Service Letter

SL: 40013
Date: 1 December 2009
Product: Compressors
Subject: 7/71 - 12/56 New Coupling Release (Lovejoy)

MODEL	PRODUCTION DATE
7/71 - 12/56	All John Deere Powered

Figure 1

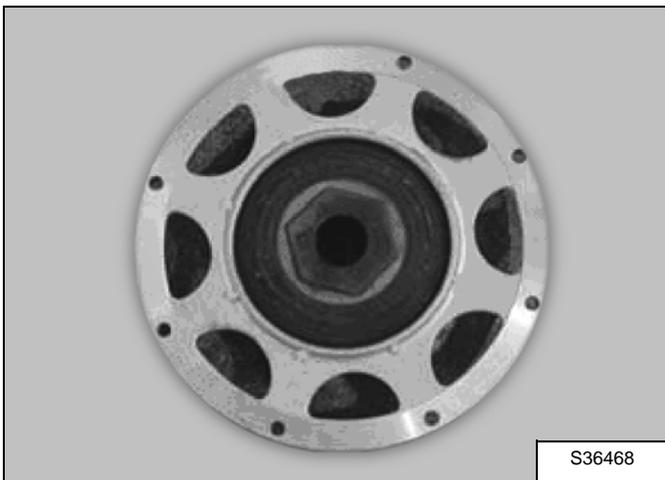
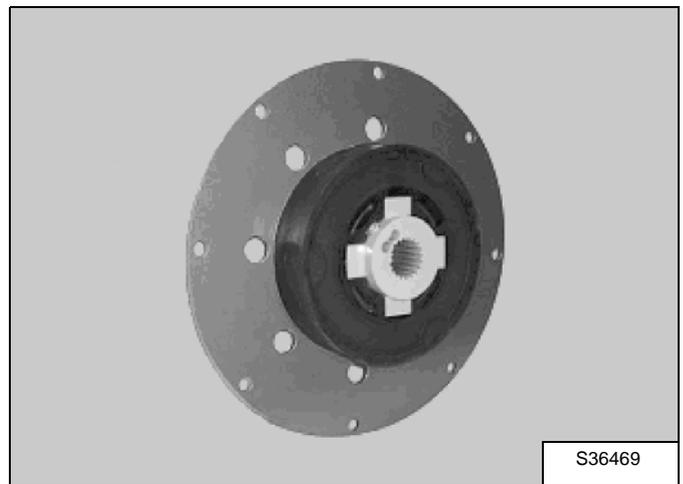
All JD powered 7/71 and 12/56 compressors previously used the LORD coupling (P/N 54755087) [Figure 1]. This coupling has now been superseded by a new type (Lovejoy) (P/N46551641) [Figure 2].

7/71 and 12/56 compressors produced after November 2008 are fitted with a Yanmar engine and LORD coupling. The Lovejoy coupling cannot be used on these units.

Figure 3

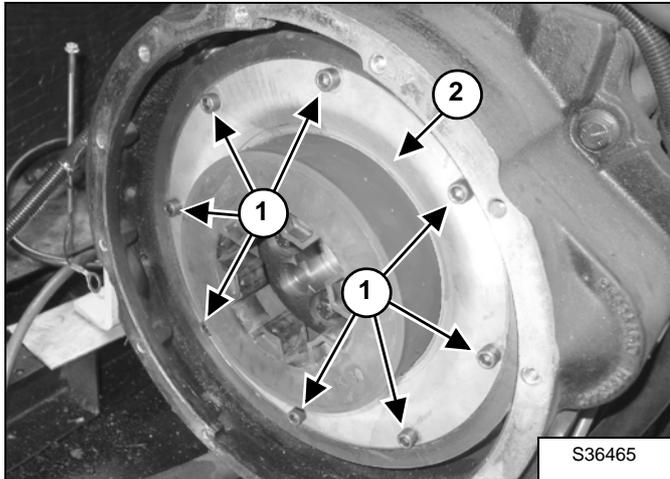
Apply Loctite to the eight screws (Item 1) [Figure 3].

Install the new coupling (Item 2) on the engine flywheel using the eight screws (Item 1) [Figure 3].

Evenly tighten the screws to 30.98 ft.-lb. (42 N•m) torque.

Figure 4

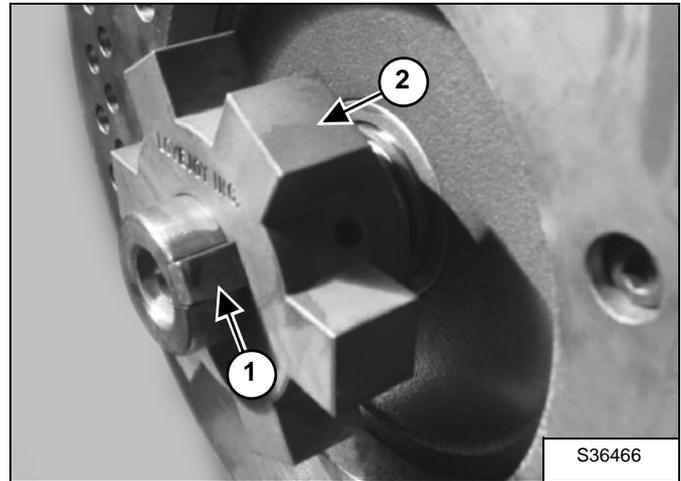
Install the key (Item 1) [Figure 4] onto the airend shaft.

Slide the coupling hub (Item 2) [Figure 4] on the airend shaft.

Figure 5

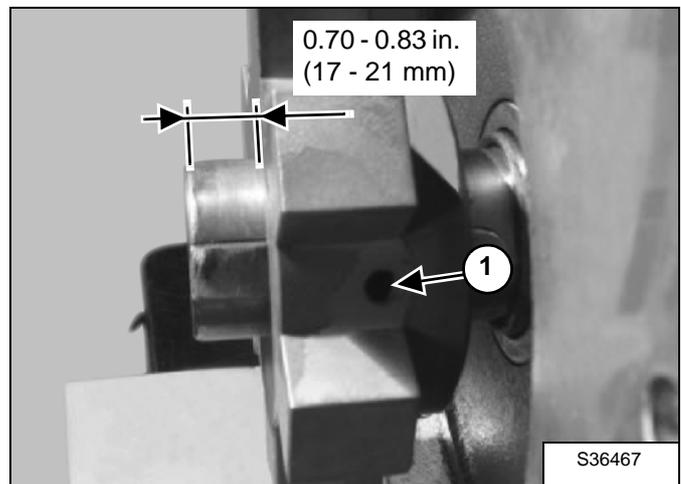
Position the coupling hub on the airend shaft as shown in [Figure 5].

Secure the coupling hub with the two set screws (Item 1) [Figure 5].

Tighten the set screws to 36.0 ft.-lb. (48,8 N•m) torque.
